**Advisory Action**  
**Before the Filing of an Appeal Brief**

10/018,469

ALEXANDRE ET AL.

FIG. 3

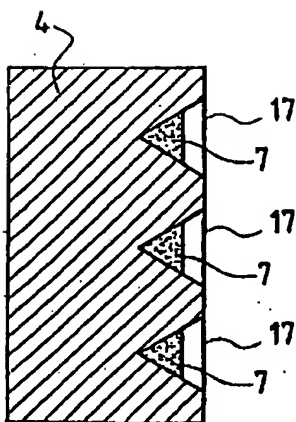
The objection to drawing figure 3 has been withdrawn in light of the remarks in the after final response filed 1/10/07.

Figures 2 and 3 were received on 7/22/04. These drawings are approved.
